144.3.3 Discovery processing

144.3.3.5 Messages

Figure 144–3—Discovery Processing service interfaces (OLT, broadcast instance)

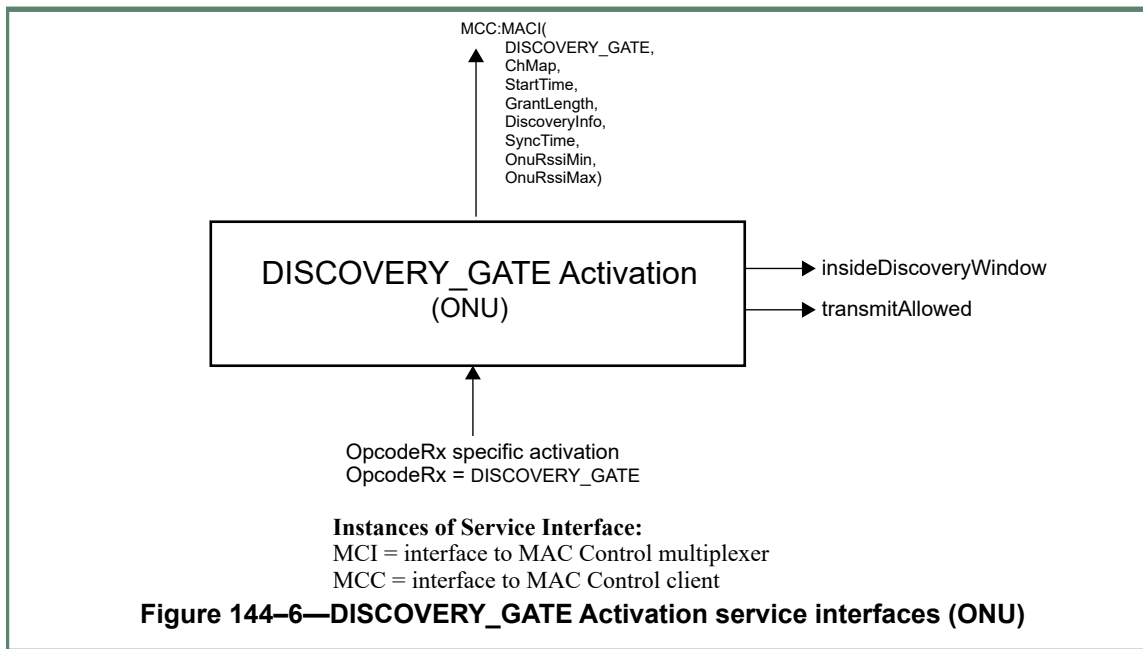
MCC:MACR(DA, DISCOVERY_GATE, ChMap, StartTime, GrantLength, SyncTime, DiscoveryInfo, DiscoveryLength, SyncTime, OnuRssiMin, OnuRssiMax)

DISCOVERY_GATE:	Opcode for DISCOVERY_GATE MPCPDU as defined in Table 31A-1.	1 2
ChMap:	A bitmap representing the wavelength channel(s) on which to transmit on during the assigned transmission slot. See Table 144-1 for details.	3 4 5
StartTime:	Start time of the discovery window.	6
GrantLength:	Length of the grant given for discovery.	7
SyncTime:	The time interval required to stabilize the receiver at the OLT.	8
DiscoveryInfo:	This parameter represents the Discovery Information field in DISCOVERY_GATE MPCPDU as specified in 144.3.7.6, defining the speed(s) the OLT is capable of receiving and speed(s) at which the discovery window is opened for.	9 10 11 12
DiscoveryLength:	Length of the discovery window process. <u>OnuRssiMin:</u> Represents the minimum RSSI threshold value for ONUs, with the LSB equal to 0.1 uW, covering the range of 0 to 6.5535 mW (~ -40 to +8.2 dBm).	13 14 15 16
<u>OnuRssiMax:</u>	Represents the maximum RSSI threshold value for ONUs, with the LSB equal to 0.1 uW, covering the range of 0 to 6.5535 mW (~ -40 to +8.2 dBm).	17 18 19

Figure 144–11—DISCOVERY_GATE Activation ONU state diagram

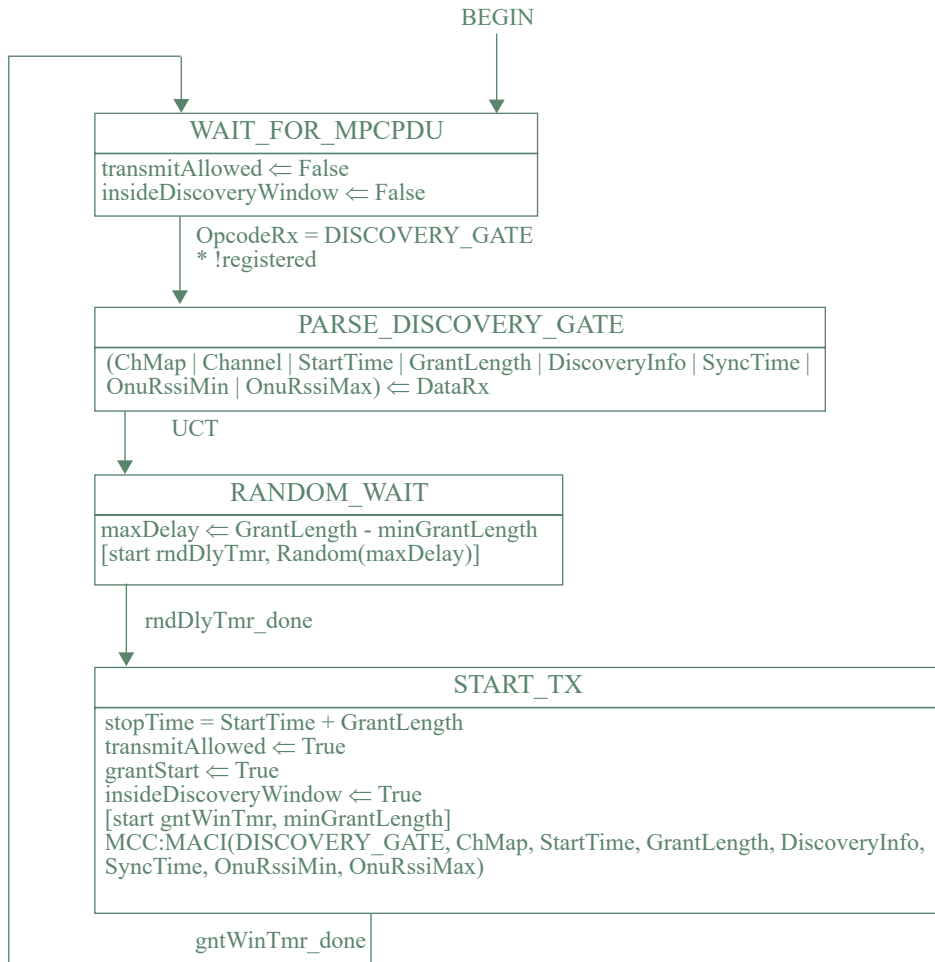
The ONU shall implement the DISCOVERY_GATE MPCPDU activation state diagram as shown in Figure 144-11.
